To: T10 Technical Committee
 From: Rob Elliott, HP (elliott@hp.com)
 Date: 13 August 2007
 Subject: 07-090r2 SAS-2 Transmit IDENTIFY three times

Overview

Suggested changes to SAS-2

Figure 3 — SL_IR (link layer identification and hard reset) state machines

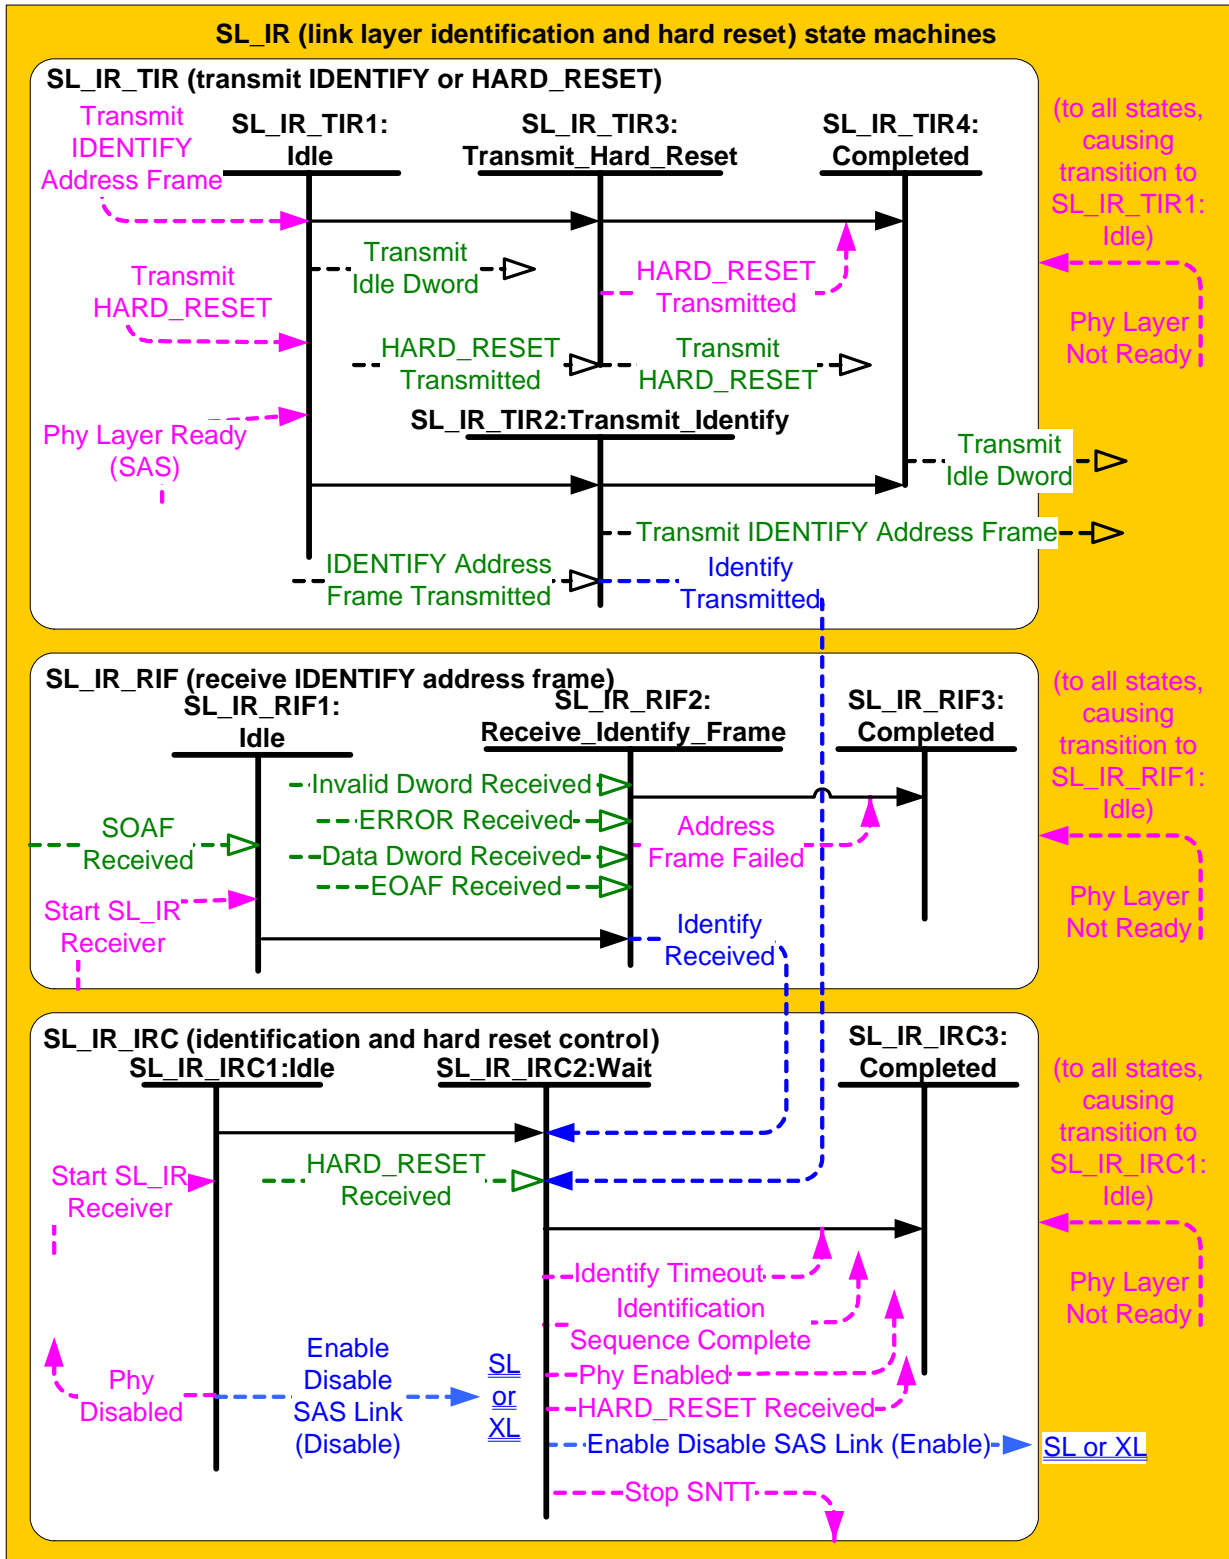
The SL_IR_TIR state machine's function is to transmit ~~a single IDENTIFY address frame~~ one or three IDENTIFY address frames or a HARD_RESET primitive after the phy layer enables the link layer. This state machine consists of the following states:

Upon entry into this state, this state shall send ~~either one or three~~ Transmit IDENTIFY Address Frame messages to the SL_IR transmitter.

[If this state sends one Transmit IDENTIFY Address Frame message, this](#) ~~This~~ transition shall occur after sending an Identify Transmitted message to the SL_IR_IRC state machine.

[If this state sends three Transmit IDENTIFY Address Frame messages, this transition shall occur after receiving three Identify Transmitted messages.](#)
